SRI VENKATESWARA CULTURAL CENTER JSP18-32

Consideration at the request of Manyam Group for Preliminary Site Plan and Storm Water Management plan approval. The subject property contains 9.65 acres and is located in Section 16, on the west side of Taft Road and south of Grand River Avenue. The site contains the Sri Venkateswara Temple building, which received Special Land Use and Site Plan approval in 2009. The applicant is proposing to construct phase 2 of the project: a 24,136 square foot, 2-story Cultural Center on the eastern portion of the site. The parking, drive areas, and utilities were previously constructed in phase 1, with only minor changes proposed now.

PLANNING REVIEW

Review Date: September 11, 2018
Review Type: Pre-Application
Project Name: JSP 18-32 SRI VENKATESWARA CULTURAL CENTER
Location: 26233 Taft Road; South of Grand River Ave (22-16-451-032)
Plan Date: July 18, 2018
Prepared by: Lindsay Bell, Planner
Contact: E-mail: lbell@cityofnovi.org; Phone: (248) 347-0484

Sri Venkateswara Temple and Cultural Center
SITE PLAN

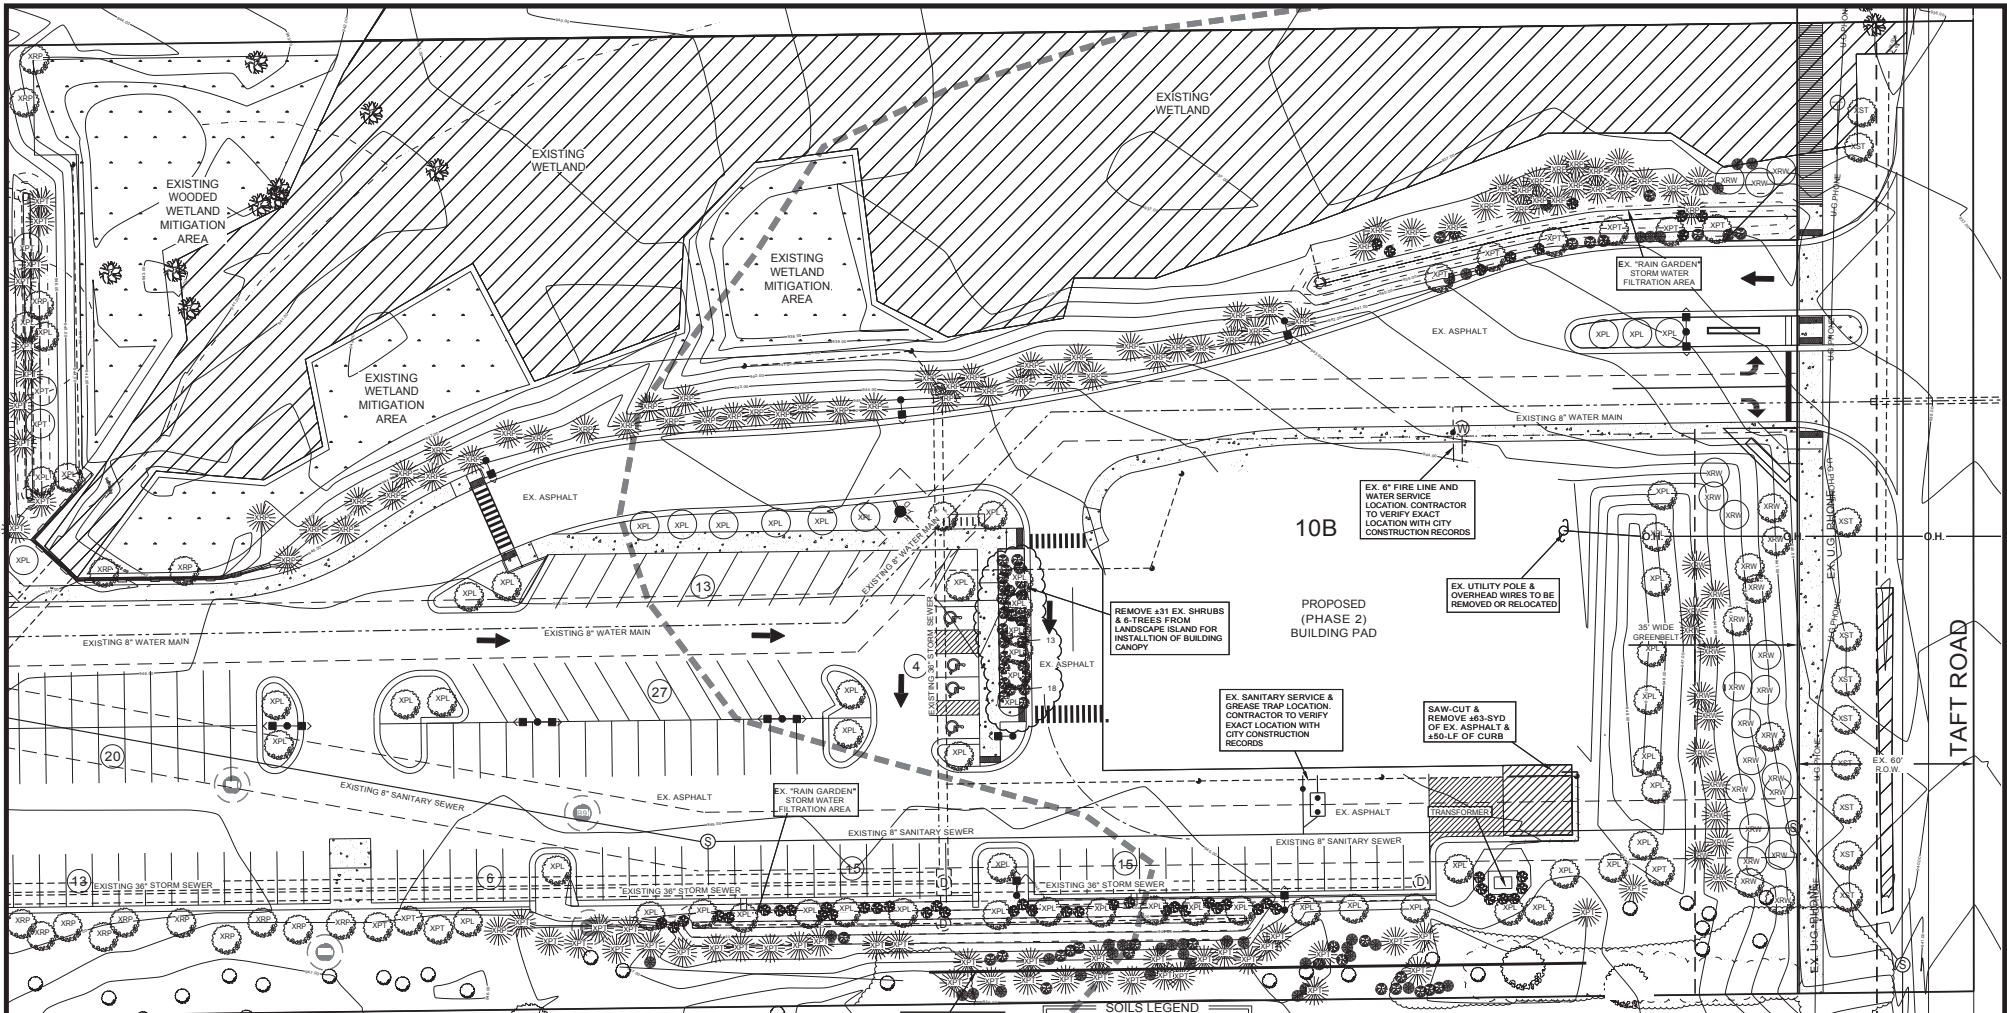
Based on the note within the "Required Parking" section on sheet 5 of 24 that states, "Simultaneous use of temple and the cultural center has been restricted per the developer's agreement with the City," additional trips are not expected to be generated with the Phase 2 development; however, the days/times of use may change or increase as a result. The developer could provide a narrative to indicate the times of operation and expected use of the Phase 2 cultural center facility to further evaluate the traffic impacts.

- i. The applicant should provide bicycle parking calculations in the required/provided parking sections on sheet 5 of 24.
 - ii. The applicant should review the layout requirements and provide the layout detail for the proposed bicycle parking to ensure compliance with Section 5.16.6 of the City's Zoning Ordinance.

1. The notes at the lower right corner of sheet 5 addresses this comment.
2. We added an additional hydrant at the Northeast corner of the proposed cultural center as previously discussed and is shown on the previously submitted site plan drawings.
3. Ordinance 11-68(F)(1)c states "In cases where the buildings within developments are fully fire suppressed, hydrants shall be no more than five hundred (500) feet apart." Both building are suppressed and the existing hydrants are all less than 500 apart. The 300 foot apart requirements may not apply in this case. We are working with the Fire Marshall to coordinate a flow test of the existing system. If flows and pressures within the existing system exceed 3,250 gpm then the Fire Chief may find that the existing hydrant configuration is acceptable. If not the Developer will agree to add the additional hydrant requested by the Fire Marshall.

Sri Venkateswara Temple and Cultural Center
 PHASE 1 AS-CONSTRUCTED & PHASE 2 LANDSCAPE PLAN NO. 1

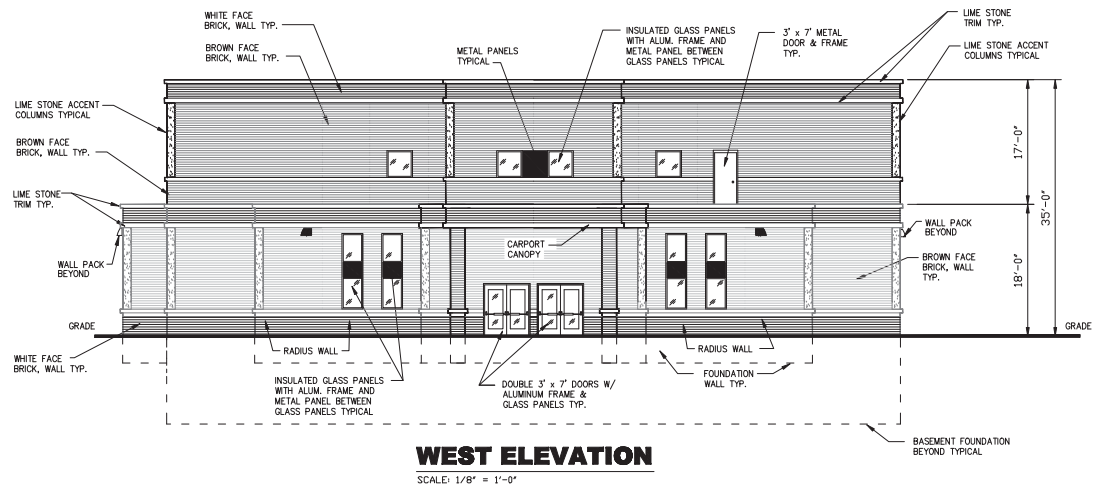
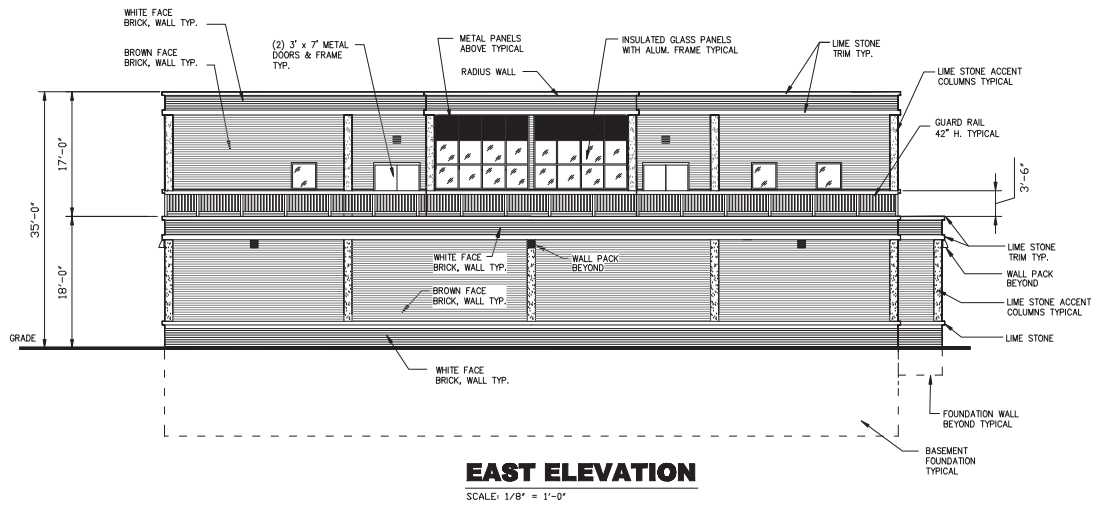
1. Based on the building perimeter, 3472 sf of foundation landscaping is required. The plans indicate that 7522sf is provided, but the boundaries of the largest area are not well-defined so it is unclear if the required area is met. **Please define the boundaries of all landscape areas.**

2. **Please provide at least 3472 sf of landscaped area near the new building. The areas must be landscaped with something other than lawn.**
3. The island area where the canopy is anchored can count toward the requirement as it is heavily landscaped with trees, shrubs and grasses. *This requires a landscape waiver but its supported by staff as it will beautify the entrance and is close to the building.*

1. Provided.
2. **Please use plants native to Michigan for at least 50% of the species included.**
